Subject: **Modification Request for Section 404 Individual Permit, Individual Section 401 Water Quality Certification, Neuse Buffer Authorization, and Issuance of Tar-Pamlico Buffer Authorization** for the Rolesville Bypass from NC 96 (Zebulon Road) to SR 1103 (Flat Rock Church Road/Clifton Pond Road), Wake/Franklin Counties, Federal Aid No. STP-401(249), State Project No. 81403001, Division 5, TIP R-2814 C. Debit \$570.00 from WBS Element 34506.1.1.

Reference: Section 404 Individual Permit, issued July 14, 2009, USACE Action ID 2008-01316

The permits stated above only approved preliminary impacts for Section C. Section C now has final design. The purpose of this submittal is to request a modification to the Section 404 permit, Section 401 Water Quality Certification and Neuse Buffer Authorization for Section C. The permit package consists of the cover letter, Hydraulic Review (Concurrence Point 4B and 4C) meeting minutes for Section C, N.C. Division of Mitigation Services (DMS) acceptance letter, Stormwater Management Plan, utility drawings, permit drawings, and roadway plan sheets.

PROJECT REFERENCE NO.	SHEET NO.
R-2814C	5
R/W SHEET NO.	
ROADWAY DESIGN ENGINEER	HYDRAULICS ENGINEER
PRELIMINARY PLANS DO NOT USE FOR CONSTRUCTION	
DOCUMENT NOT CONSIDERED FINAL UNLESS ALL SIGNATURES COMPLETED

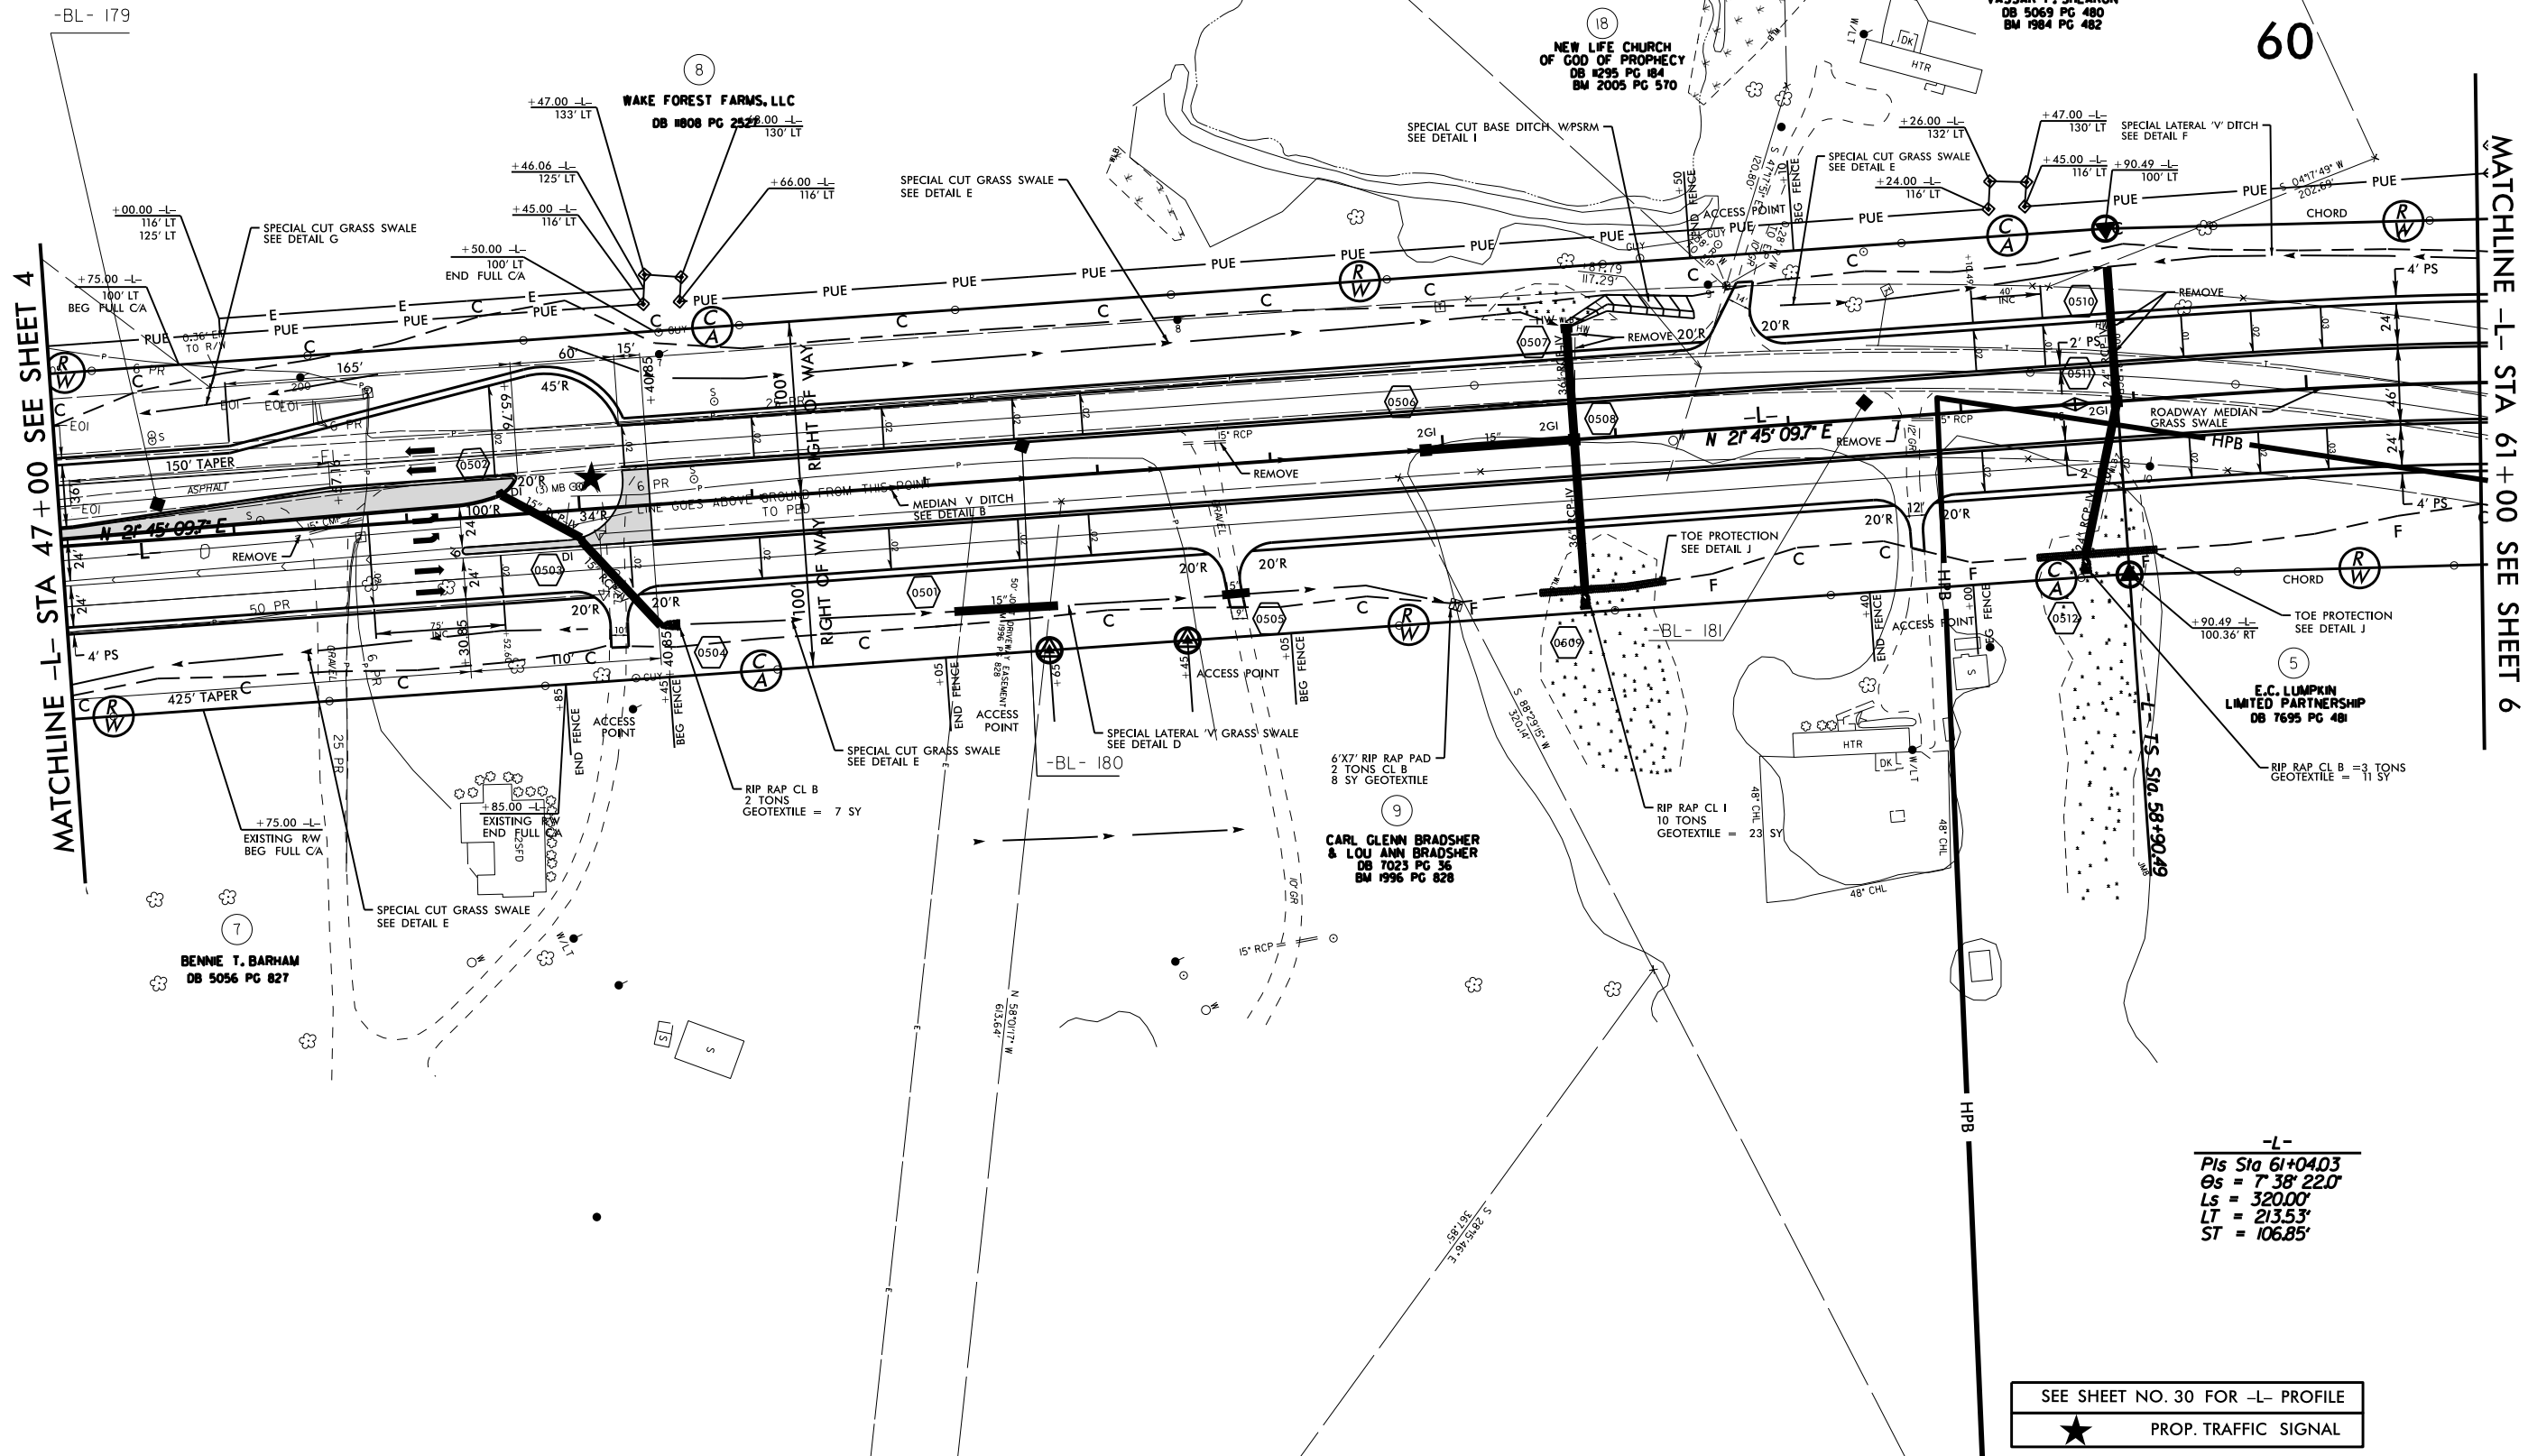
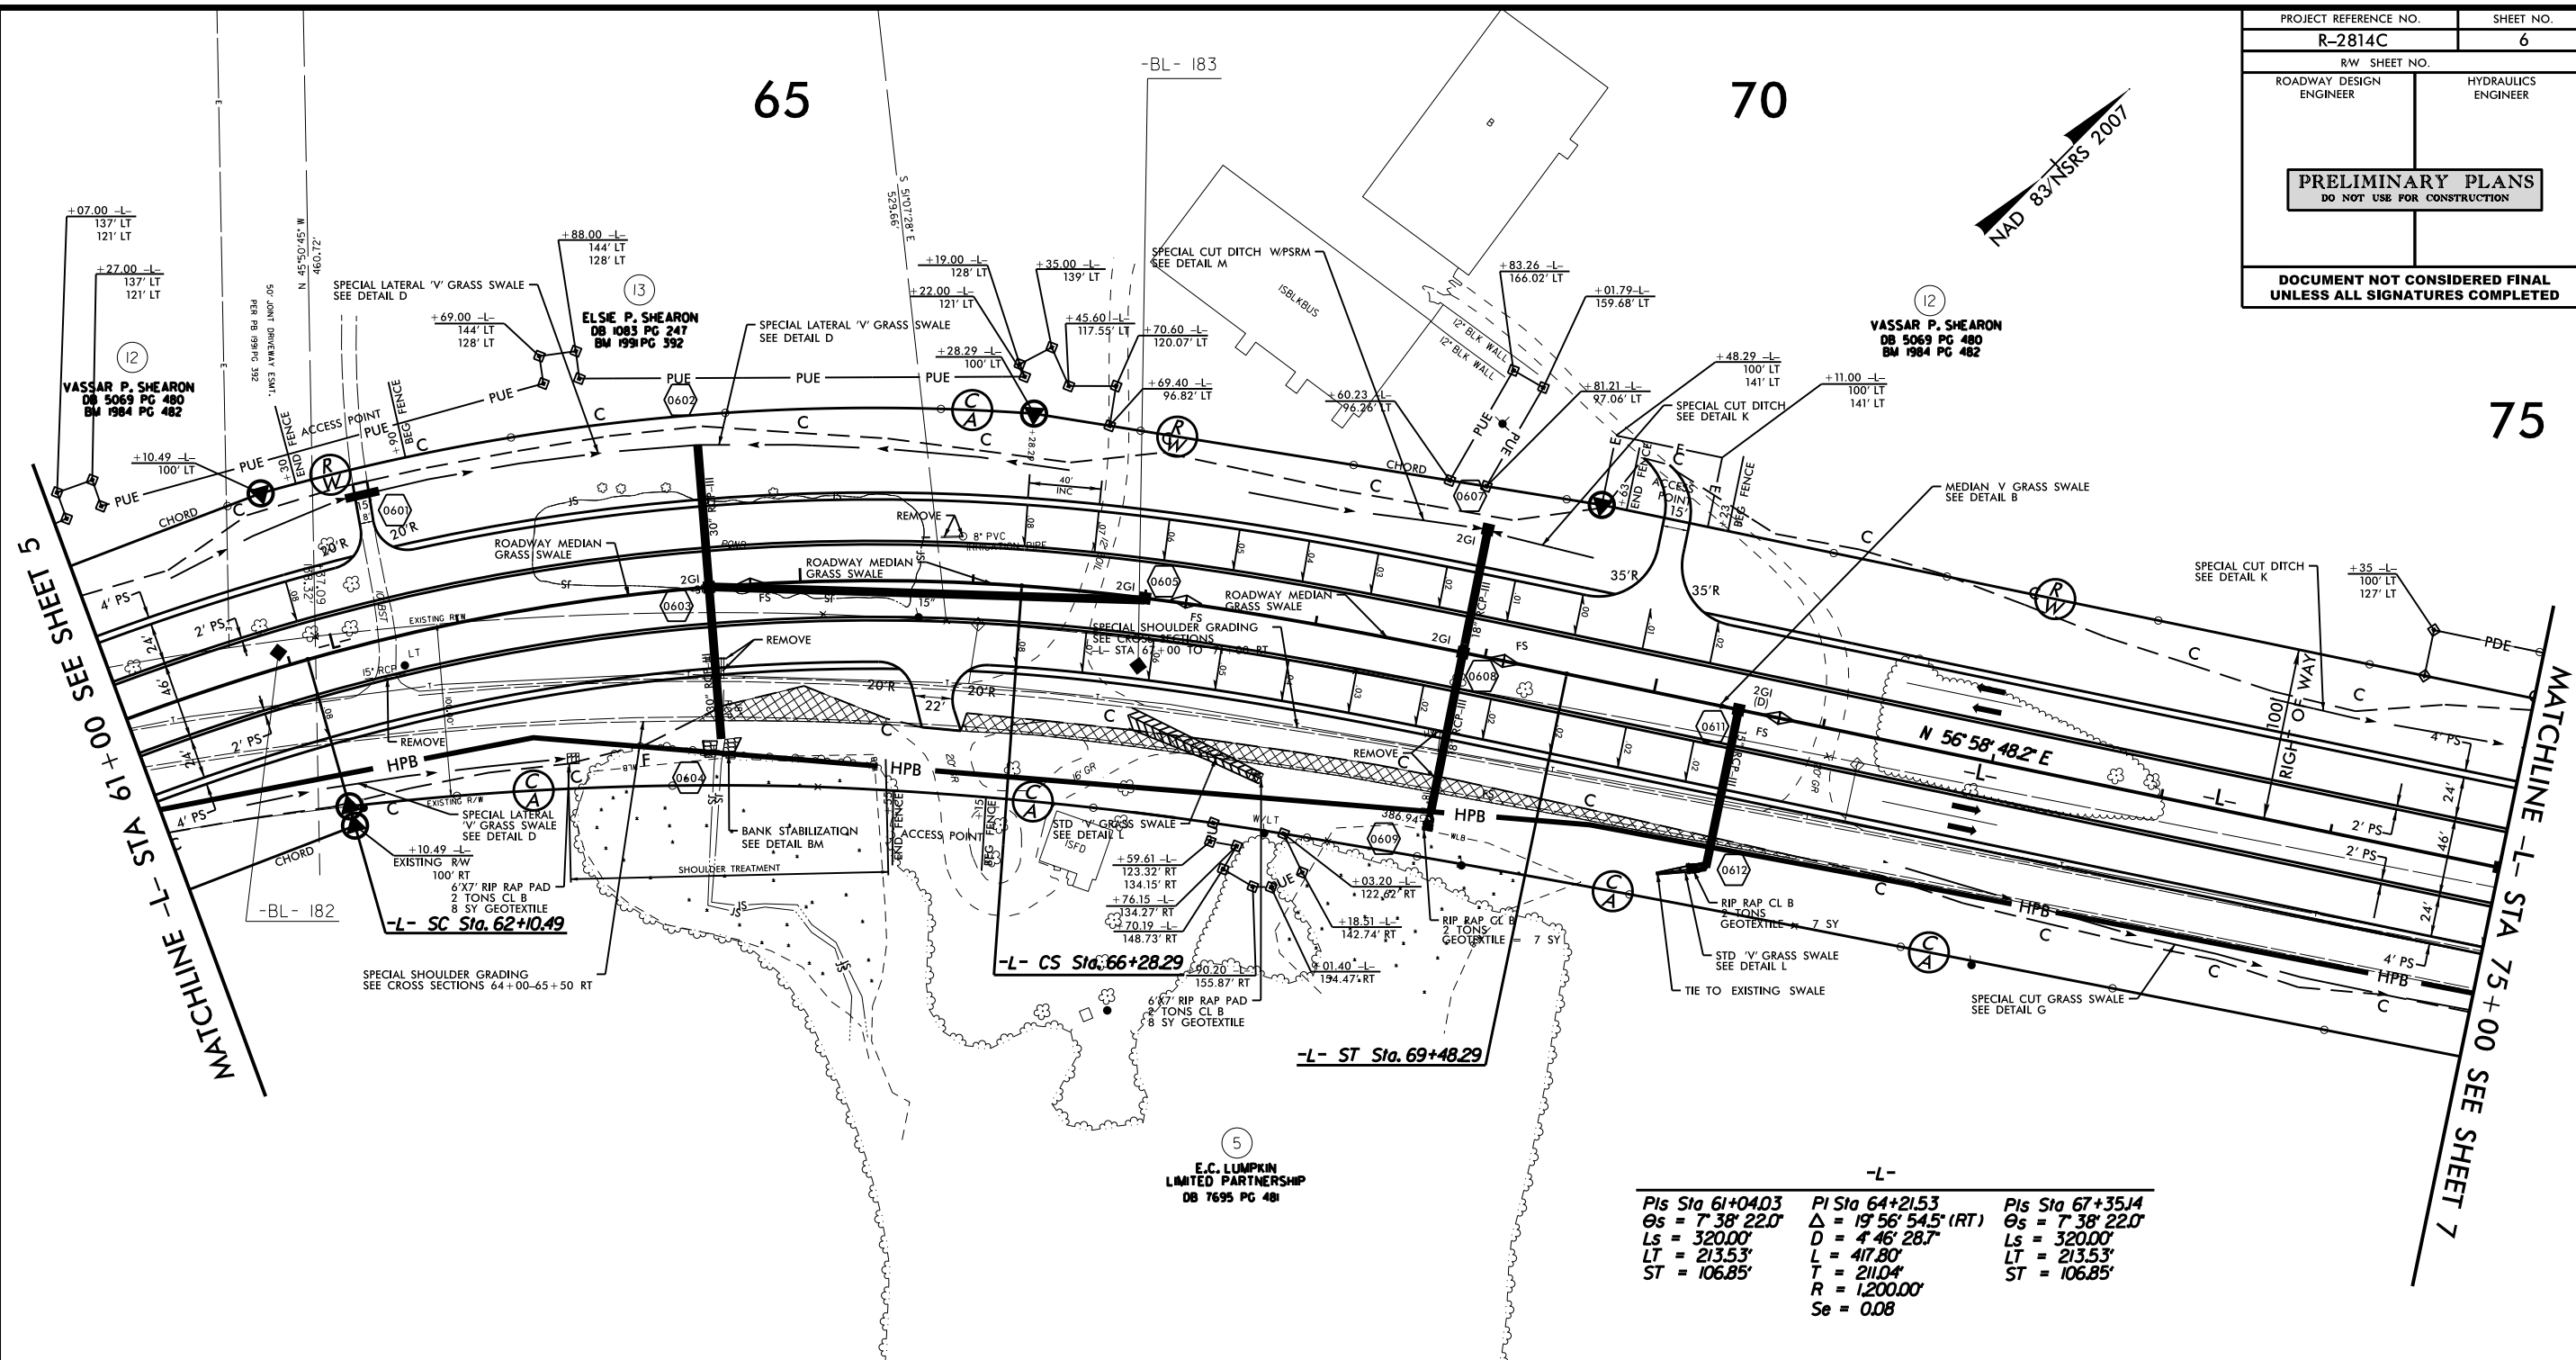
There are three wetlands on this sheet; Wetland AO, Wetland AC and Wetland AD. This portion of the project is open shoulder and will incorporate ditches and grass swales where possible to obtain treatment prior to jurisdictional features.

Pond on this sheet is non-jurisdictional. There was a question about the non-jurisdictional call on the pond located at -L- Sta. 55+00 Lt, since it appears on the soils map as a "blue line". Rachelle says there is a letter on file stating this pond is non-jurisdictional.

MATCHLINE -L- STA 159+00 SEE SHEET 12

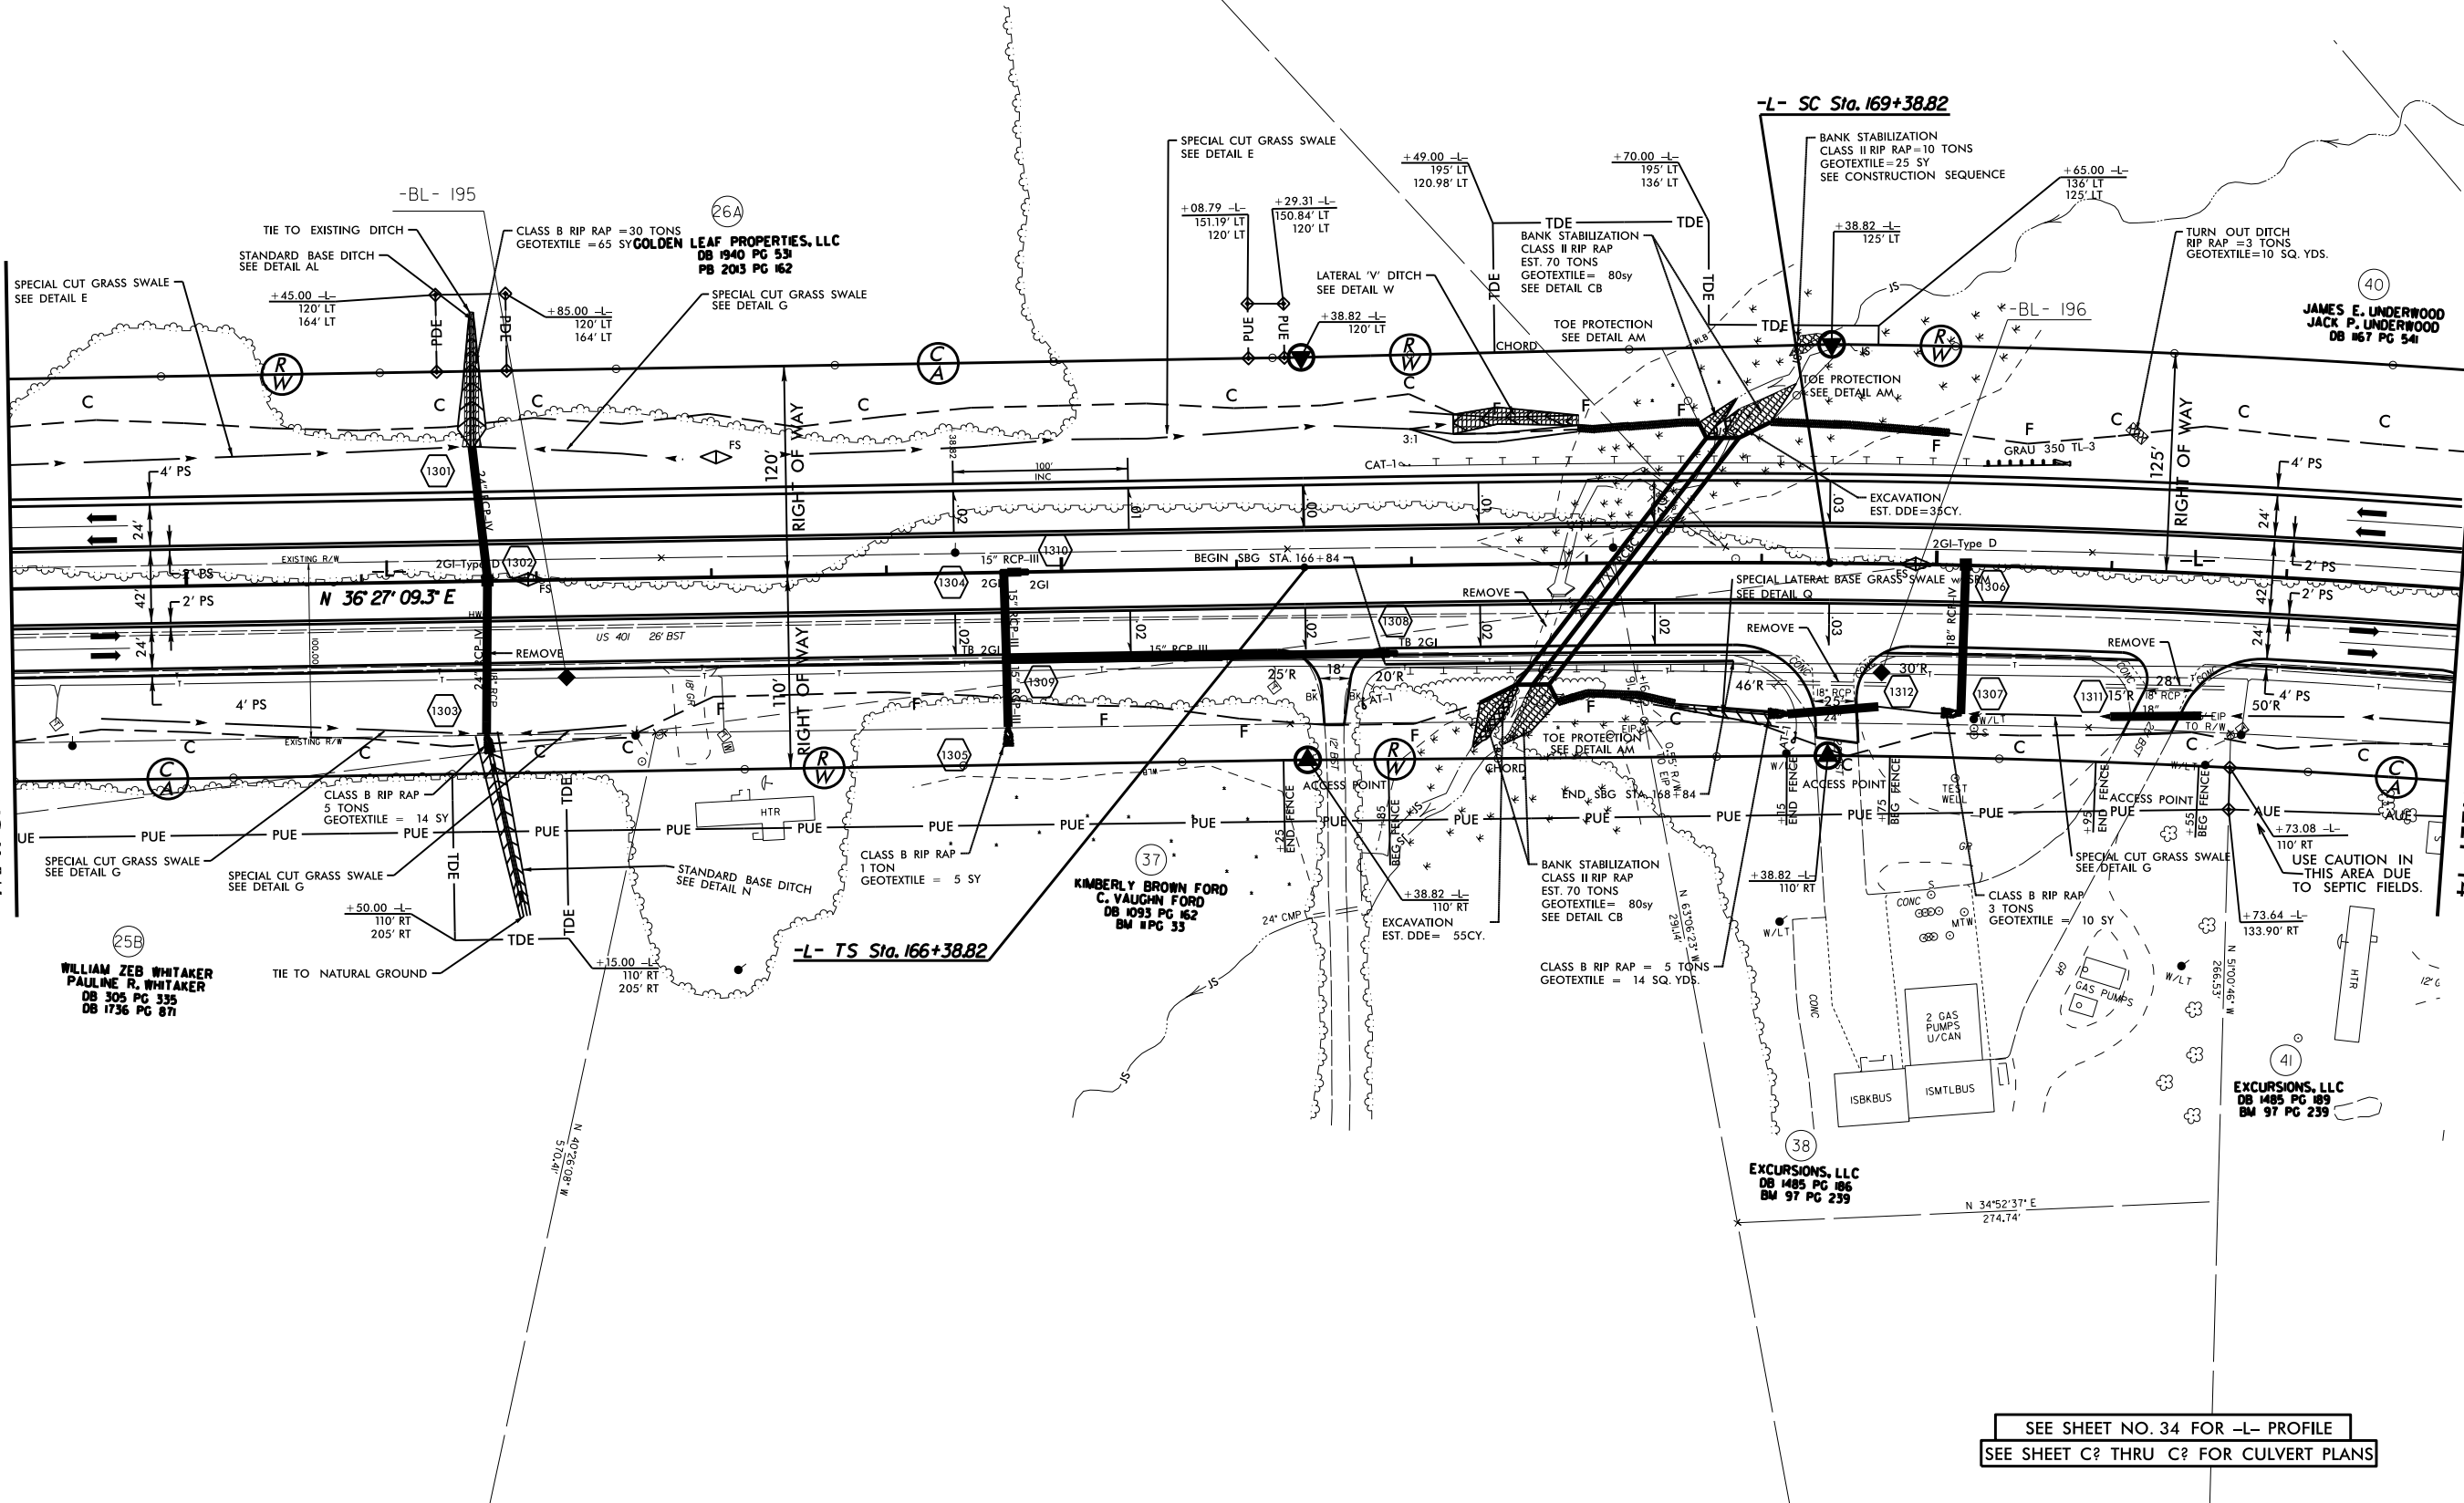
The two wetlands on this sheet are Wetland AF and Wetland AG. Wetland AF will be a total take. Wetland AG consists of a series of depressions. Roadway will provide one driveway per parcel. A driveway pipe will be added if a proposed driveway cuts off hydraulic connectivity to or from Wetland AG.
